**Consideration of Radiation in
Hazardous Waste Produced from
Horizontal Hydrofracking**

*Report of E. Ivan White
Staff Scientist for the
National Council on Radiation Protection*

Figure 1: Comparison of Exposure to NORM in Marcellus Shale for Vertical Wells and Horizontal Wells

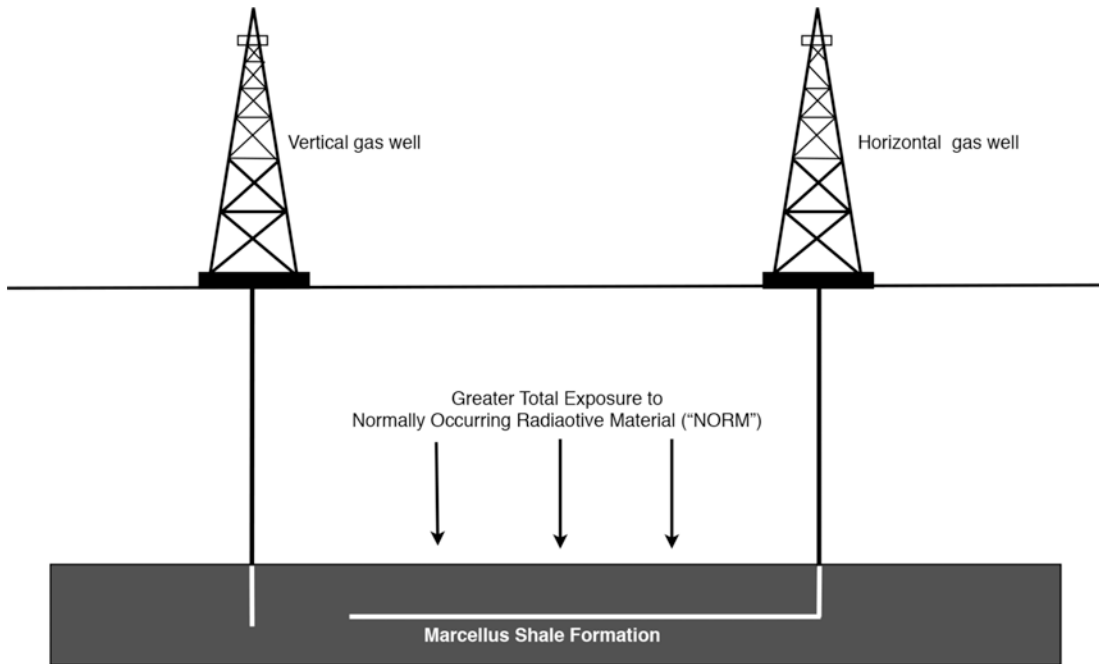
Based on my experience in assessing potential transport pathways for radiation and a review of the DEC's internal report, I find two serious flaws that must be addressed and corrected prior to any final determination related to hydrofracking in New York State. The first is that the report examined a very different type of drilling than that which is being proposed. The second is that the authors used RESRAD in a limited way, resulting in faulty conclusions.

The 1999 DEC report examines vertically-drilled oil and gas wells in New York State that have been hydrofracked. This is very different from the *horizontal* hydrofracking currently being proposed for New York State. Vertical wells of the type measured by the NYSDEC are typically 1500-3000 feet deep with minimal penetration into the Marcellus shale formation. Horizontal slickwater hydrofracking wells, on the other hand, reach depths of 6,000 feet before turning horizontally for an additional mile or so. These deeper, longer wells have a much greater overall exposure to the Marcellus Shale formation and the radioactive materials contained within it, and thus an increased likelihood of bringing that radioactivity to the surface. (See Figure 1)

Figure 2: Pathways for Radiation Migration Through Air

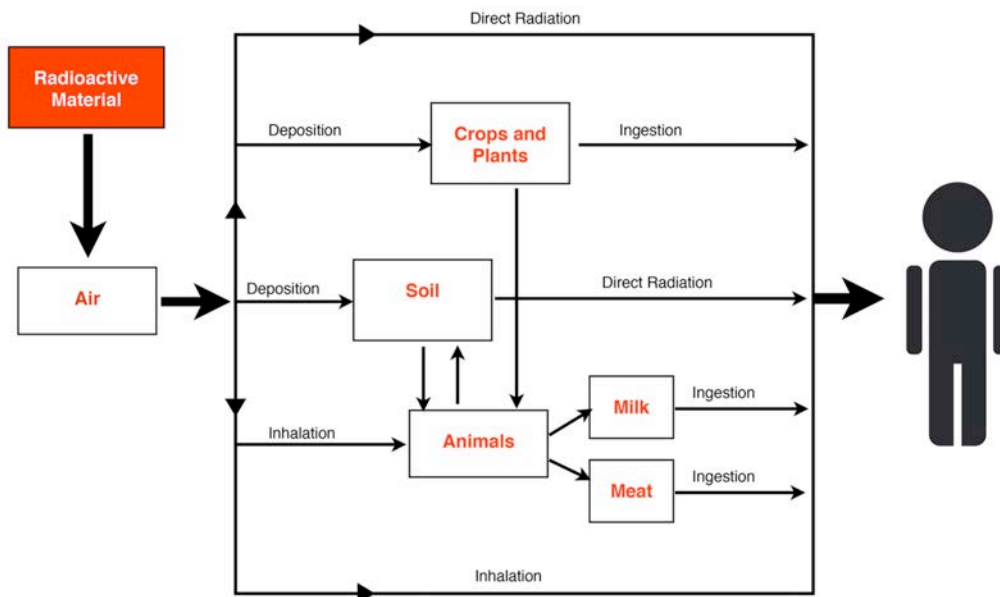
The second flaw is that RESRAD was not properly used to determine **all** of the potential pathways of the radiation. The following diagrams illustrate the potential pathways for radionuclides released into the environment in an uncontrolled manner, in air or in water.

3. RESRAD was made precisely for situations like this, but it must be used properly to produce valid conclusions. Picking and choosing isolated scenarios and ignoring downstream exposures, as was done in the Report, is not a proper use of RESRAD and renders the conclusions invalid. All of the potential pathways over a span of decades as the hazardous material accumulates and the public's body burden build up must be considered to produce a valid RESRAD conclusion. This applies to both radioactive and chemical waste.
